**Enclosure 1, Attachment 2 of
MFN 06-313S08**

ROAMM Review With Responses

SEVERE ACCIDENT MANAGEMENT
in SUPPORT of the ESBWR
DESIGN CERTIFICATION DOCUMENT

SEVERE ACCIDENT MANAGEMENT FOR ESBWR

Figure 3.2.1a The BiMAC positioned inside the LDW. Initial cooling is provided by the flow into the BiMAC [Deluge line shown on the right]. The LDW is flooded independently by direct flow [Deluge line shown on the left].
 [Schematic, not to scale. See also Addendum 3.2 at the end of this chapter].

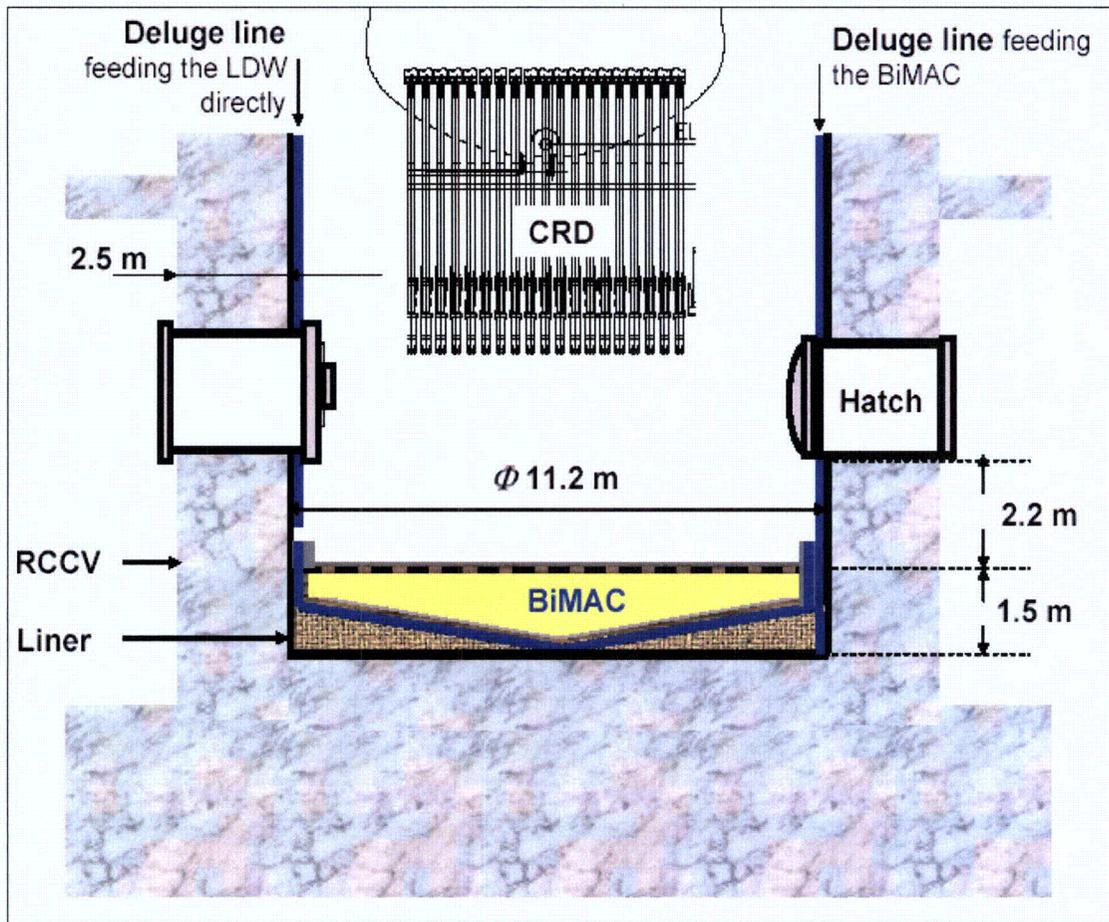
This is in response to Prof. Griffith's request for further clarification of the BiMAC design concept. In addition to Figure A.1 in Chapter A, Figure 3.2.1aa shows the placement of the BiMAC inside the containment. A scaled 3D rendering of the BiMAC basic pipe structure is shown in Figure 3.2.1ca (1/4 symmetry). As noted throughout details such as angle of inclination, sacrificial material choice, and BiMAC cover (LDW floor), will be optimized on the basis of the BiMAC coolability experiments (currently in progress).

Figure 3.2.1aa. Same as Figure 3.2.1a, but in a different perspective.
